*Firearms Technology Industry Services Branch*

907010:MCP  
3311/304296

This refers to your correspondence to the Bureau of Alcohol, Tobacco, Firearms and Explosives (ATF), Firearms Technology Industry Services Branch (FTISB), which accompanied your submitted sample of an "Adjustable Pistol Stabilizing Brace" mounted on a semiautomatic pistol. Specifically, you asked whether the subject device could be lawfully installed on a handgun.

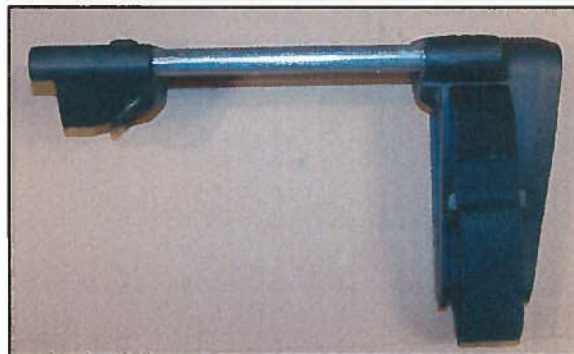
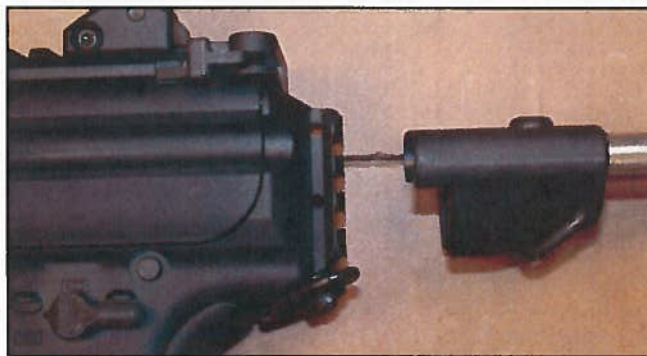
Further, the submitted brace contains a series of raised ridges at its rear (see photo below):

The subject ridges on the rear of the submitted sample serve no functional purpose in the design of a pistol brace; however, the ridges do provide a non-slip, gripping surface, a feature commonly associated with butt stocks/shoulder stocks as well as firearms designed and intended to be fired from the shoulder. You indicate production models will not have this raised surface so as to preclude its usefulness to be shouldered.

Your submission would therefore be approved for use on handguns similar to that attached to your submission, provided there are no raised ridges on the rear of the brace. Its use on smaller, or more conventional handguns, would not be authorized because the purported intent and design offers no benefit for small handguns.

In closing, FTISB finds that the submitted sample is approved for use as a pistol stabilizing brace provided the raised ridges are removed from the rear of the device and not added at a later time.
